OFFICE OF NEW REACTORS

**ASSESSMENT OF WHITE PAPER SUBMITTALS ON
DEFENSE-IN-DEPTH; LICENSING-BASIS EVENT SELECTION, AND SAFETY
CLASSIFICATION OF STRUCTURES, SYSTEMS, AND COMPONENTS
(REVISION 1)**

**NEXT GENERATION NUCLEAR PLANT
PROJECT 0748**

**Figure 1 Proposed dose acceptance limits for the NGNP safety analyses
(Source: Figure 3 in the NGNP LBE white paper)**

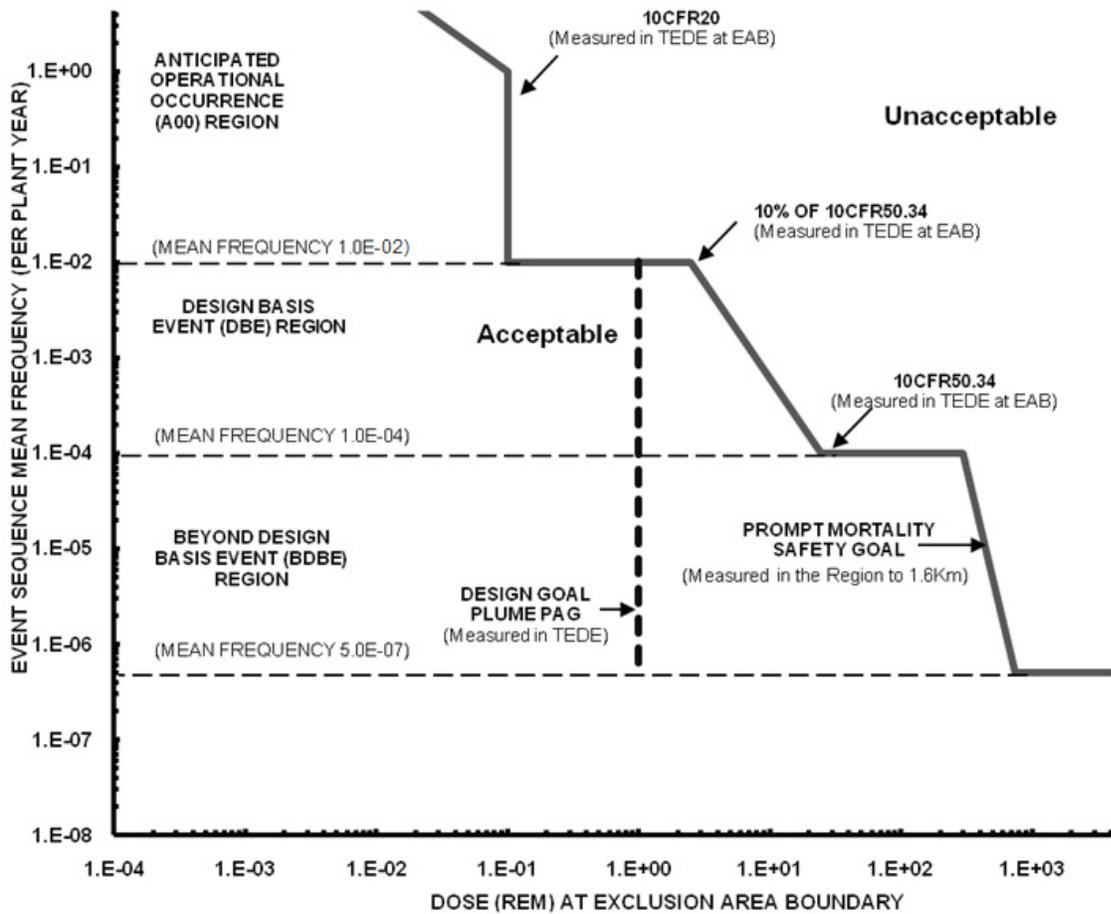
DOE/INL proposes dose acceptance limits on the LBE consequences and the analysis basis for the LBE categories, which are generally consistent with the NGNP LS with several significant exceptions. Figure 1, a reproduction of Figure 3 from the NGNP LBE white paper, depicts the proposed dose acceptance limits for the NGNP safety analyses.

The event frequency versus dose consequence acceptance line shown in Figure 1 is generally referred to as an “F-C curve.” For events in the AE frequency region, construction of the proposed F-C curve is based on the dose limits in 10 CFR Part 20. For events in the DBE frequency region, construction of the proposed F-C curve is based on the dose limits in 10 CFR 50.34.⁷ For events in the DBE region, the proposed F-C curve has been constructed in such a manner that would allow a reduced dose as DBE frequency increases. For the DBAs (which are selected and derived from the DBEs), DOE/INL proposes that dose criteria in 10 CFR 50.34 apply (i.e., without reduction). For events in the BDBE frequency region,

construction of the proposed F-C curve is based on the prompt mortality safety goal. DOE/INL proposed that the dose limits be associated with, and apply at, the NGNP EAB.

The overall construction of the proposed F-C curve is intended to generally follow an iso-risk curve to allow low doses for relatively frequent events and higher dose limits for rare events. The intent of the construction of the F-C curve is to ensure that the overall NGNP risk for all LBEs combined will meet the NRC's safety goals.

The staff recognizes that there are a large number of ways to construct an F-C curve that use the dose acceptance criteria of existing NRC regulations and applies them to inferred frequency ranges for the event categories to meet the above stated objectives. For example, the proposed frequency consequence curve shown in Figure 3-3 in NUREG-1860 was developed in connection with the NRC staff's feasibility study for a risk-informed and performance-based regulatory structure for future plant licensing. The development of the F-C curve shown in Figure 3-3 of NUREG-1860 was done using the same LWR regulations that DOE/INL used to develop its proposed F-C curve. The development of the F-C curve in NUREG-1860 also includes consideration of additional dose acceptance criteria associated with national and international radiological health standards.
